The Calcutta Gazette

WEDNESDAY, JULY 7, 1920.

NOTICES TO MARINERS.

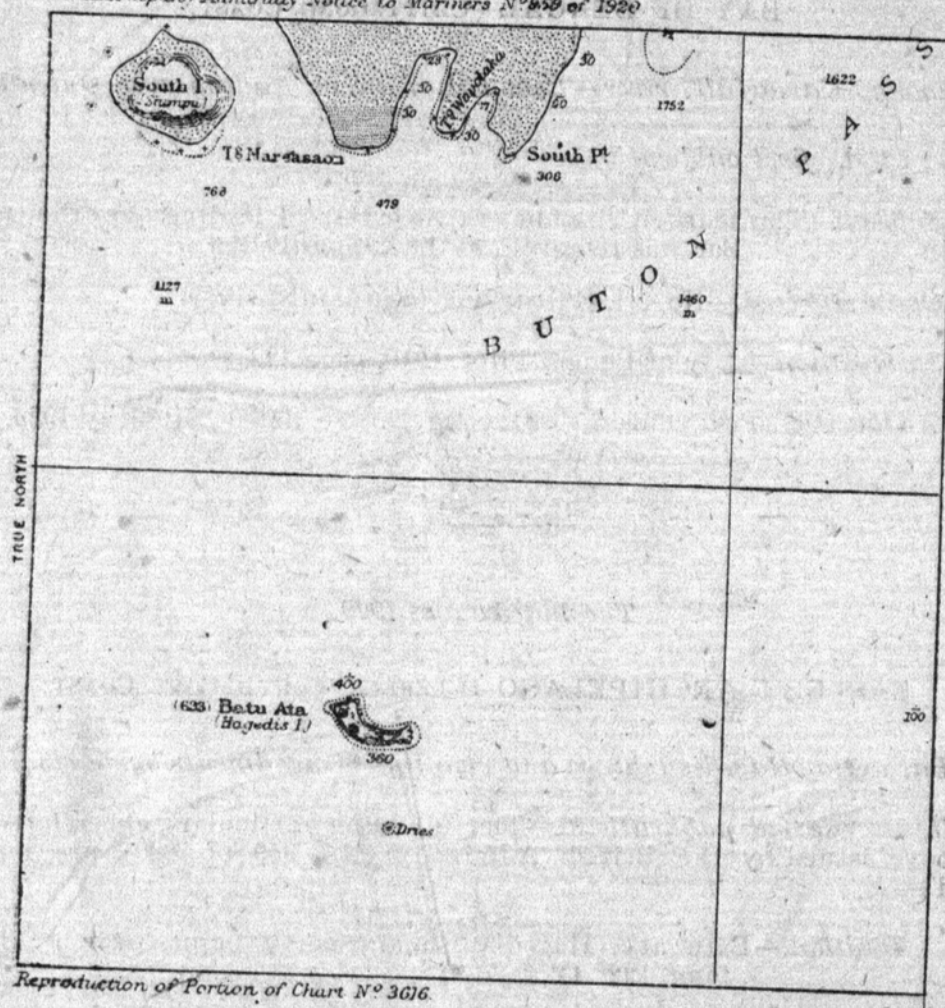
(a) Reef formerly shown on charts about 10 miles southward of Batu ata, and marked “E. D.”

b) Six Feet bank eastward of Batu ata.

(c) The circular bank southward of Six Feet bank.

Reproduction of Portion of Chart No. 942A

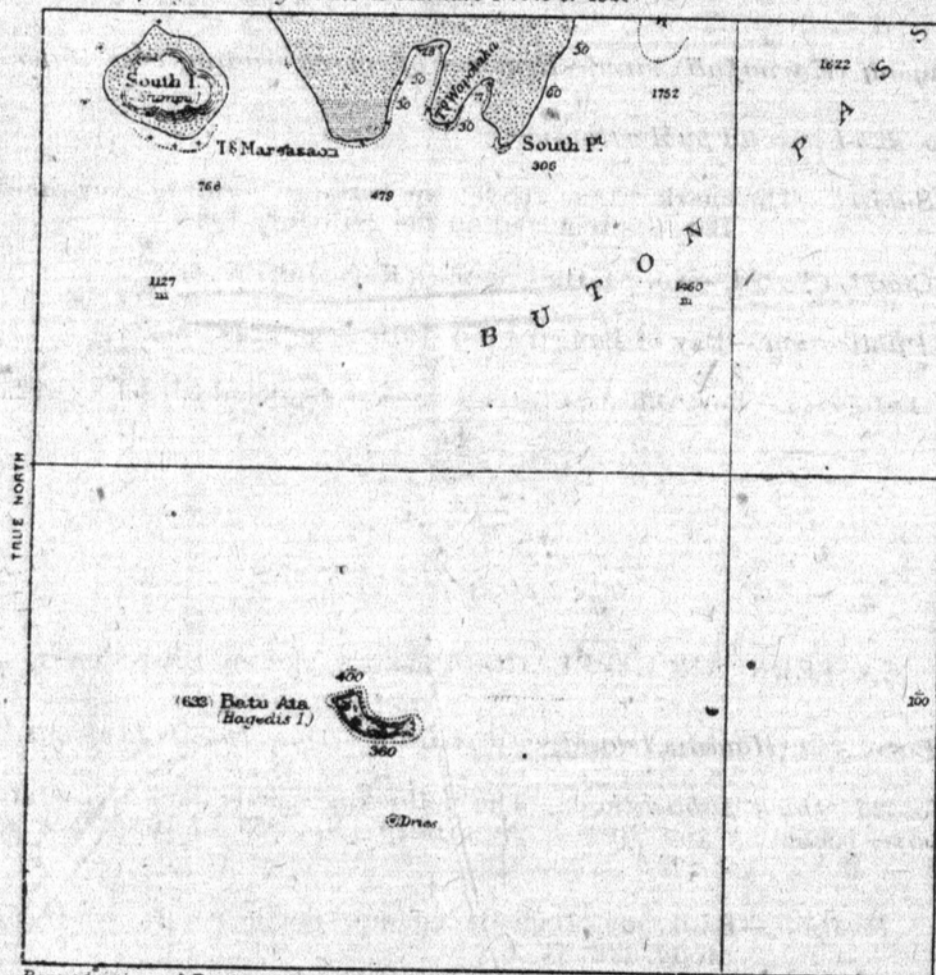
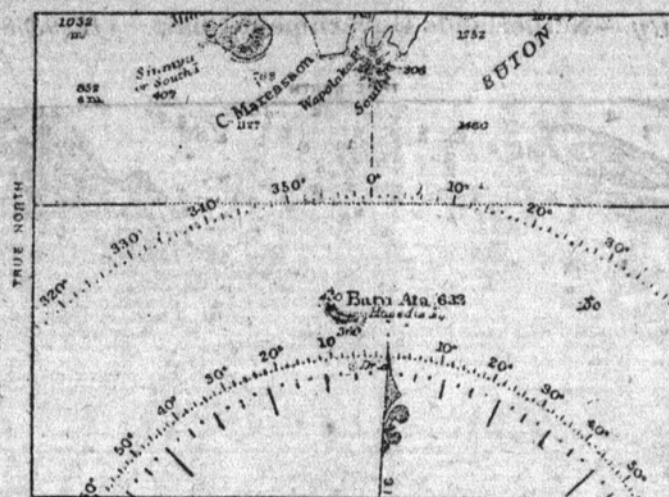
(*a*) Reef formerly shown on charts about 10 miles southward of Batu ata, and marked “E. D.”

(*b*) Six Feet bank eastward of Batu ata.

(*c*) The circular bank southward of Six Feet bank.

Charts affected.—No. 3370, San Bernardino strait and approaches.

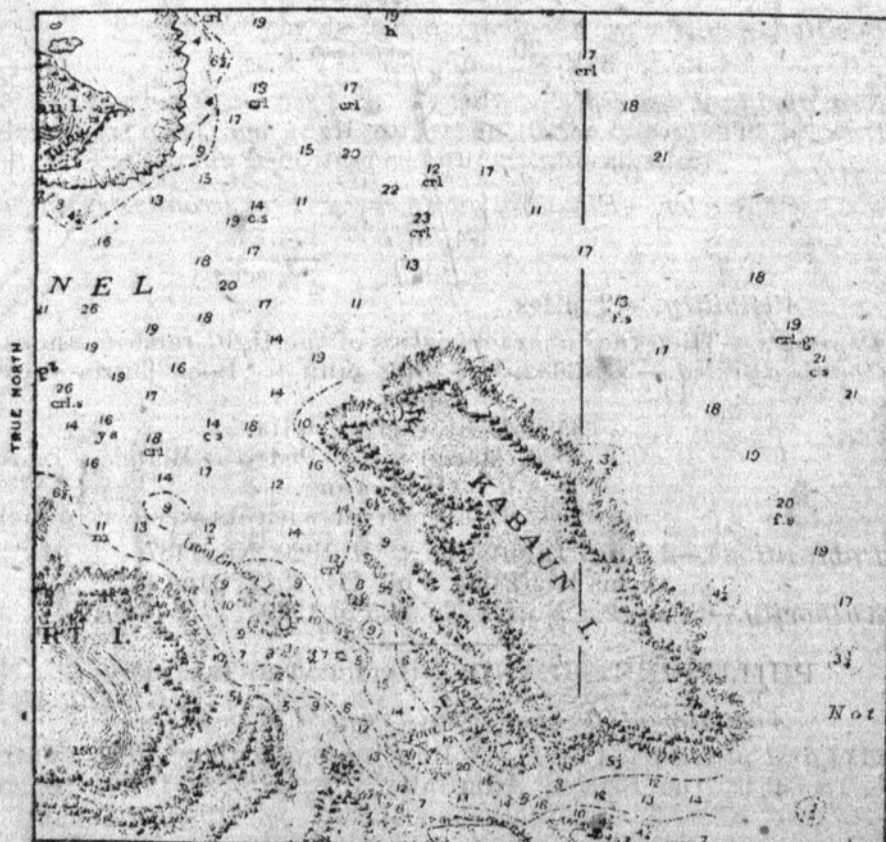
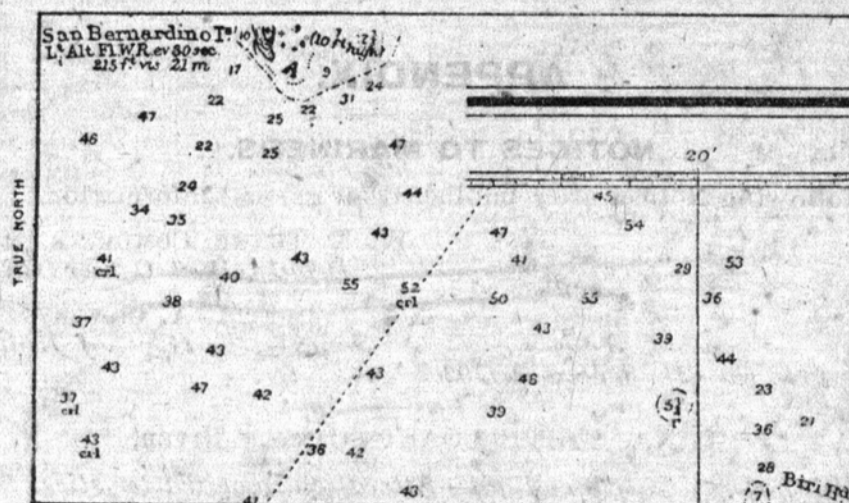
Details.—The accompanying reproduction of portions of chart No. 3370 show the necessary amendments with regard to shoals in the vicinity of San Bernardino islets and Kabuan island.
